Preservation Department – Item 2, LPC-22-07227

**345 Decatur Street – Bedford-Stuyvesant/Expanded
Stuyvesant Heights Historic District
Borough of Brooklyn**

NYC LANDMARKS PRESERVATION COMMISSION PRESENTATION (08/15/23)

Community Board & Landmark Preservation Commision Presentation 345 Decatur - Historic Photograph

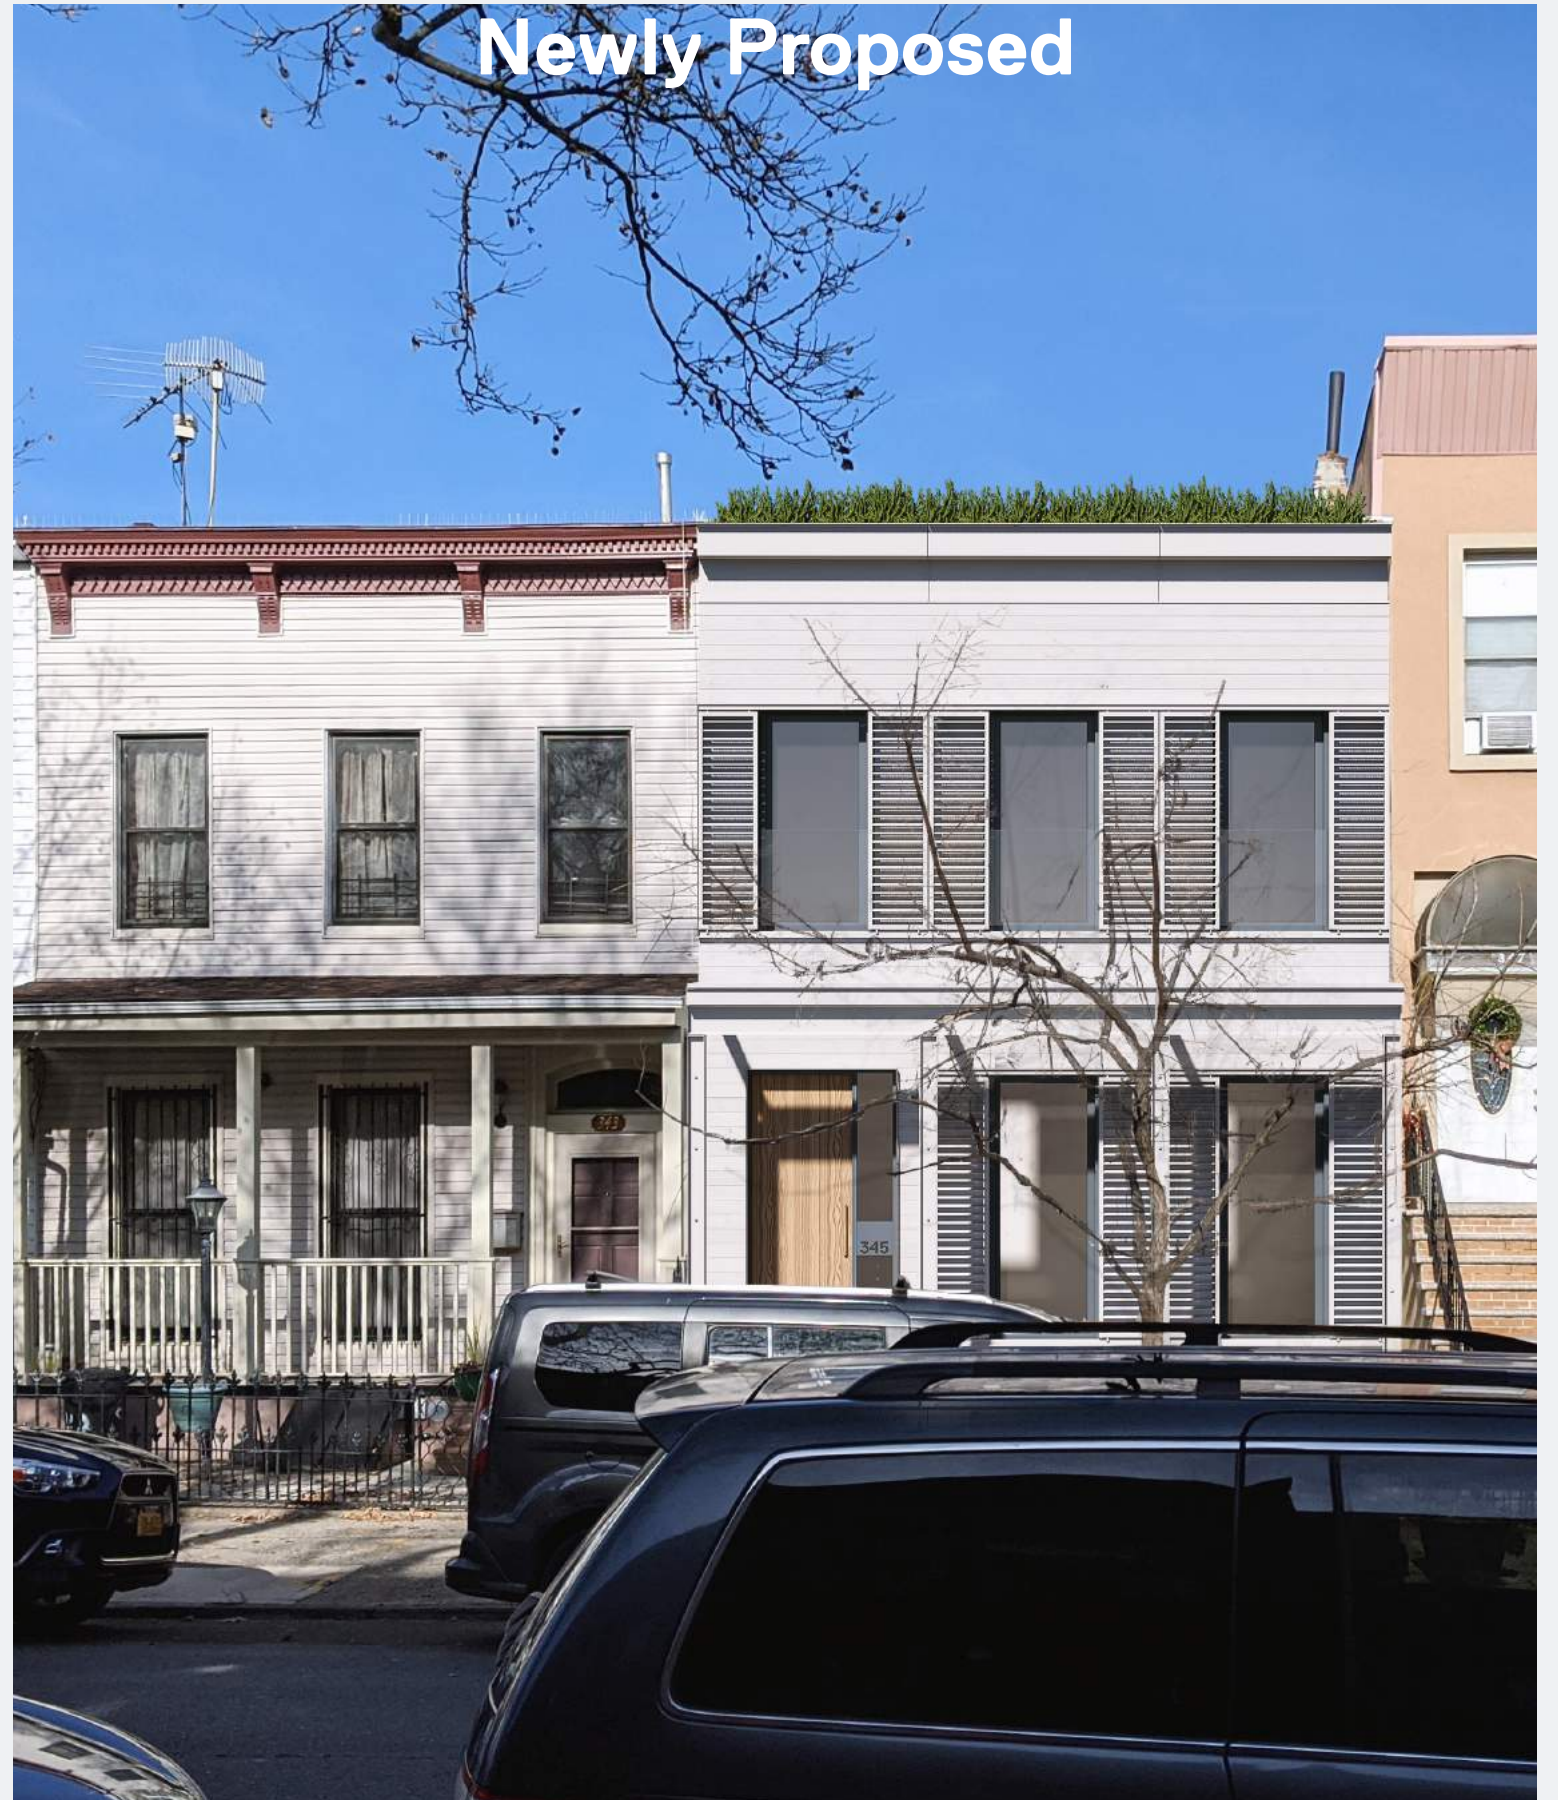
- There were some concerns with the front façade with regards to the porch, the cornice, the windows, the shutters, and the wood cladding:
 - Porch Structure made heavier and refined the alignment with the neighboring porch.

- Cornice made to read heavier and was re-detailed to match more closely the size and detailing of the original.
 - Reduced the window sizes at the upper floor and modified the proportions to introduce a hierarchy between the ground floor windows and the upper floor windows similar to the original facade.

- Sliding shutter were switched from single sliding panels to symmetrically opening bi-parting panels.
 - The cedar siding is now coated with an opaque grey stain lessening the board variation and creating a more uniform surface that is more in keeping with the neighborhood.
